November 18, 2024

**Re: Motiv Technical Bulletin for the following recall notices**

- 24v781 - Connector Retention (Non School Bus)
- 24v782 - Connector Retention (School bus)
- 2024-627 - Connector Retention Transport Canada)

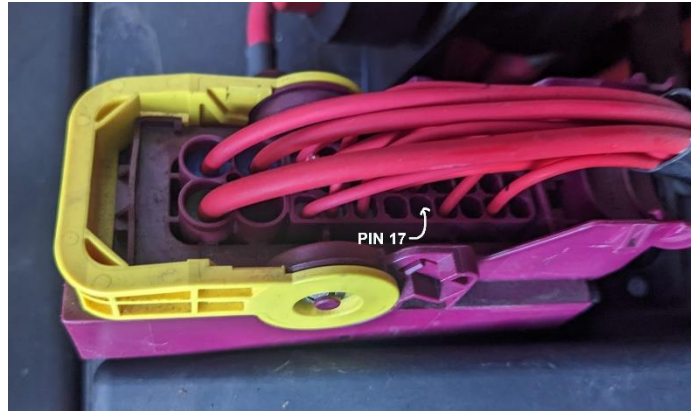
3. Disconnect the positive lead to the 12v battery.
4. Remove 3.6mm Radlok cable. It's the smaller Radlok cable that goes from the Wurth fuse box to the DC-DC. Completely remove it from the truck. Cover the now exposed Radlok pin with heat shrink.

5. Install new “unswitched” power cable for fuse box – P/N 840-115034-024. Unplug P75 (purple leavyseal) from Wurth fuse box. Remove back shell. Remove clear plug from position 17 on P75. Disengage yellow TPA on P75. Insert MCP 2.8 end of new power cable into position 17. Reengage yellow TPA. Reinstall back shell.

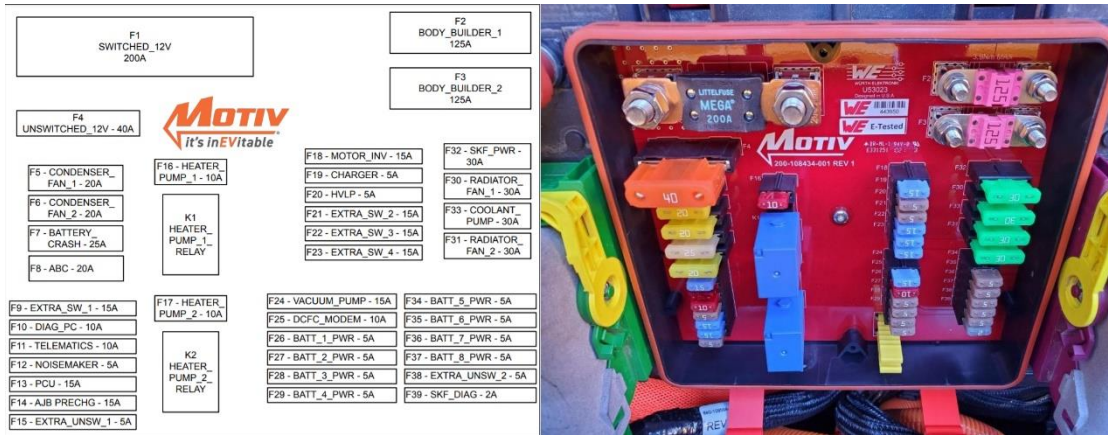
6. Install M8 ring terminal end of new power cable on the positive terminal of the 12V DC-DC – tighten to 13 ft/lbs. Use zip ties to secure power cable to existing harnesses.
